SI B11 05 13
Engine

Turbocharger Coolant Return Pipe Leaking

With S63T engine

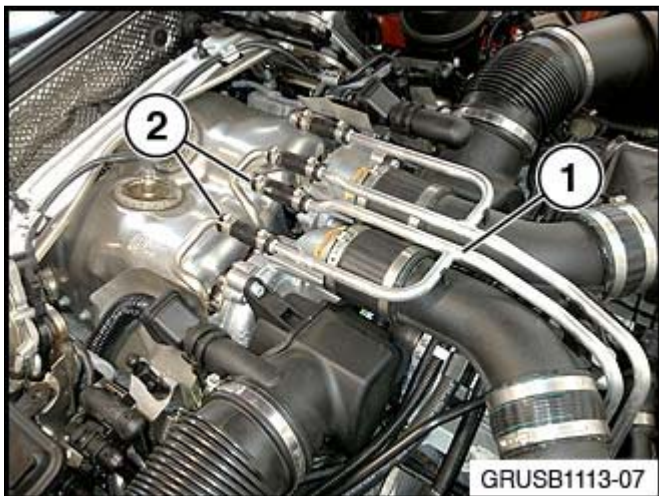
A Check Control message for low coolant level is displayed. There are traces of coolant leaking in the engine compartment at the turbochargers.

The auxiliary coolant pump for the turbochargers does not run during an MSA shutdown. Frequent MSA starts and stops could result in excessive temperatures in the cooling circuit of the turbochargers.

Verify the coolant leak is coming from the coolant return line of the turbochargers (1). Replace the line and clamps (2).

Reprogram the vehicle with ISTA/P 2.49.0 or higher. This latest programming will enable the auxiliary coolant pump to run during an MSA shutdown.
